Groundwater Application Review Summary Form

Application # G- 19431

PUBLIC INTEREST REVIEW FOR GROUNDWATER APPLICATIONS

A. GENERAL INFORMATION: Applicant's Name: Green Clover Farms c/o Chris Copp County: Clackamas

Well Location Map

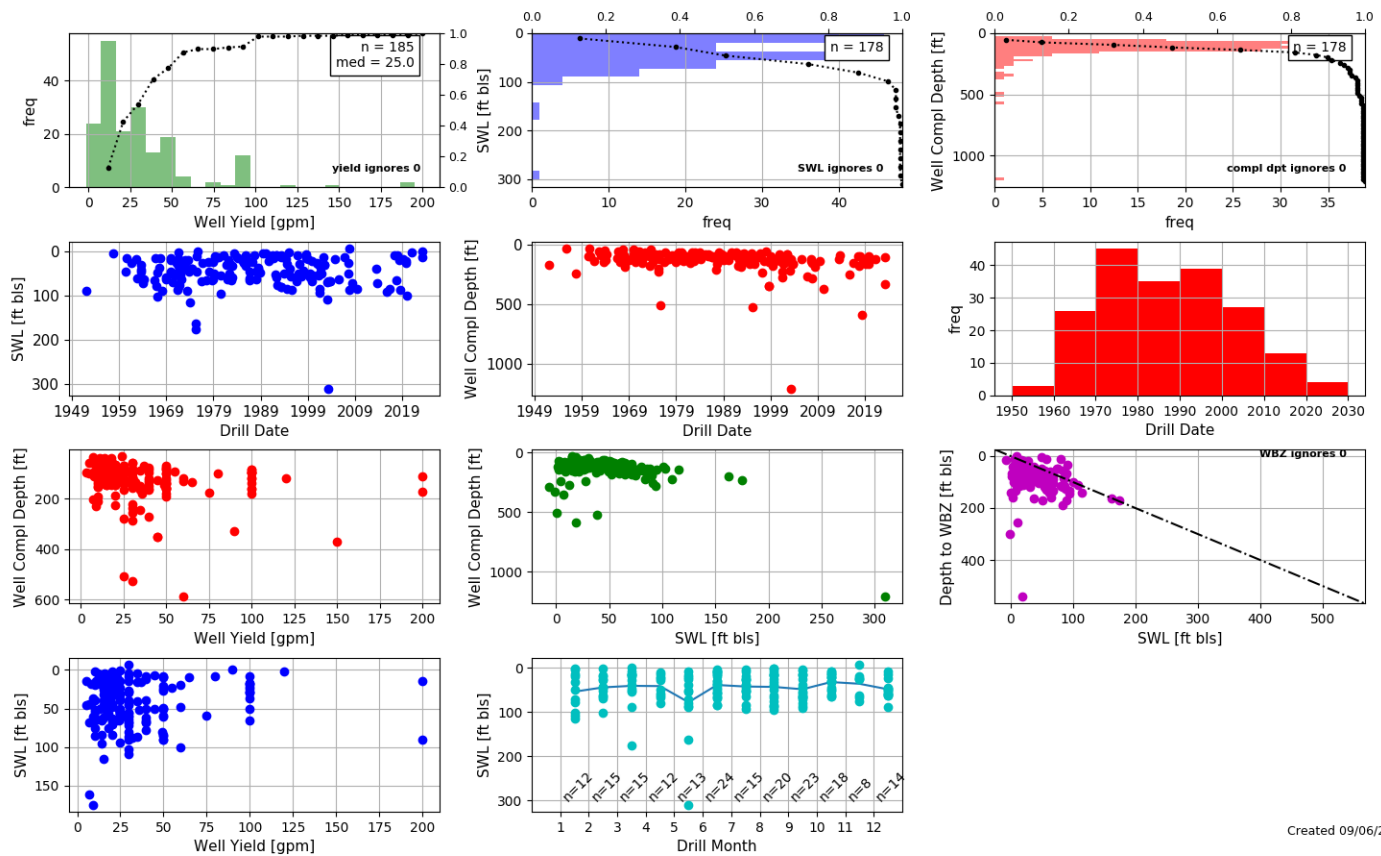
A4. **Comments:** The proposed POA/POU is approximately 6 miles east of Oregon City. The applicant proposes nursery use on 0.5 acre by one well already constructed, CLAC 73540.

- B3. **Groundwater availability remarks:** The proposed POA/POU location is on floodplains of the ancestral Clackamas River which were then incised by the current Clackamas River, approximately 1,900 feet north of the POA. The proposed POA is on an intermediary upland terrace with steeper and higher elevation terraces further north and south of the Clackamas River. The Clackamas River and tributaries are deeply incised into underlying Quaternary alluvium, the Tertiary Troutdale Formation, and/or the Sandy River Mudstone. Basalt flows of the Boring Lava and High Cascade volcanics are also present in the area to the north and south, which were then incised by smaller streams, producing substantial local topographic relief (Leonard and Collins, 1983; Conlon and others, 2005; Gannett and Caldwell, 1998). The proposed POA appears to produce from Quaternary alluvium, with minor amounts of volcanic gravel reported in the well log.

Water-Level Measurements in Nearby Wells

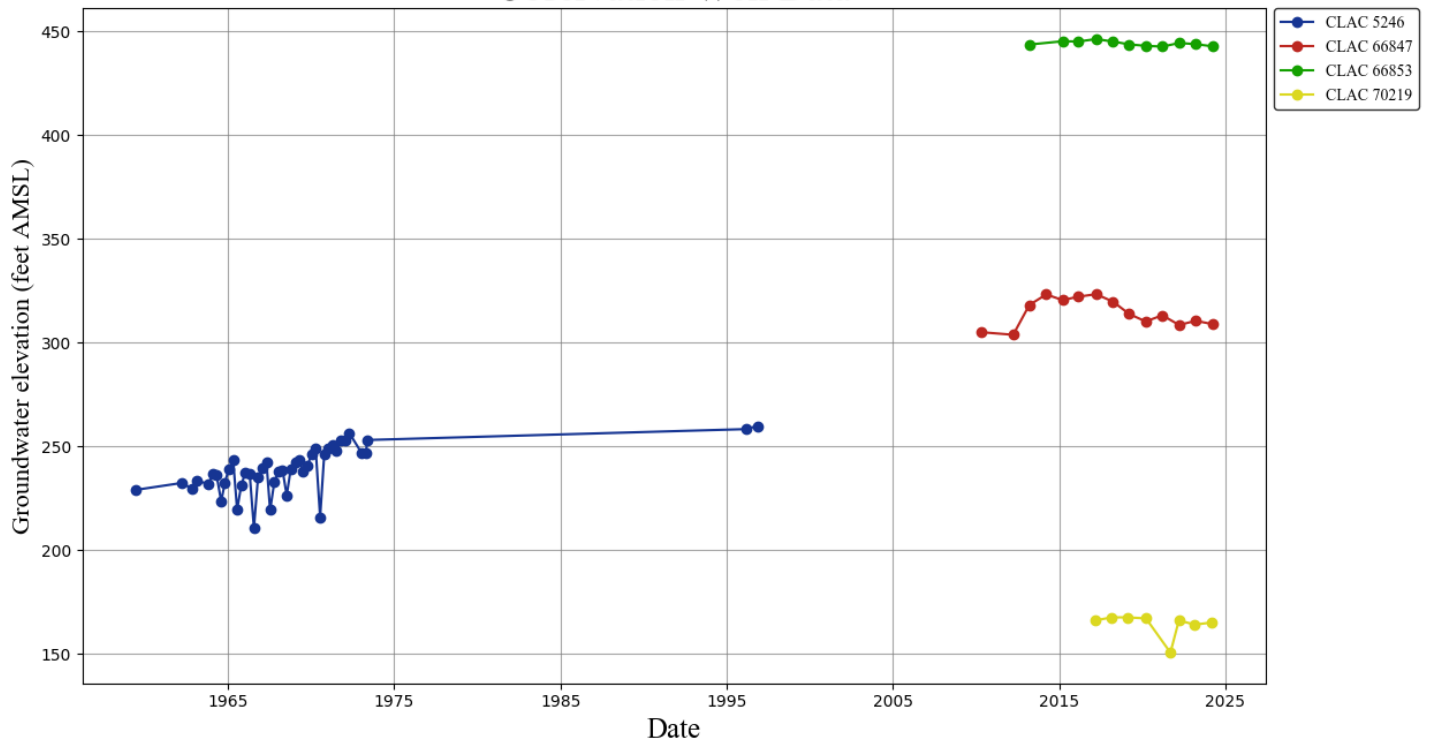
Four nearby wells producing from Quaternary alluvium and with sufficient water level data for evaluation were identified within approximately 2.5 mile of the proposed POAs, ranging in total depth from 161 to 350 feet bls. Reported water level elevations for these wells range from about 150 feet above mean sea level (amsl) to 450 feet amsl, mostly higher in elevation

than the SWL reported in the POA due to the substantial topographic relief near the POA. Water level data for these wells are generally stable over the time period available with seasonal variability up to 30 feet. Although the well construction and elevations do not correspond exactly to the proposed POA, the water level data is representative of trends within nearby similar construction and water-bearing zone(s).

No nearby wells fully penetrate the ~600 ft deep alluvial system in this area, and thus potential injury to nearby groundwater users was not assessed for this review. Additionally, the proposed withdrawal rate is very low (~5.6 gpm) and therefore unlikely to impact nearby wells.

However, permit condition 7RLN is recommended to assess potential future injury concerns, and as a means to monitor long-term groundwater conditions in this area.
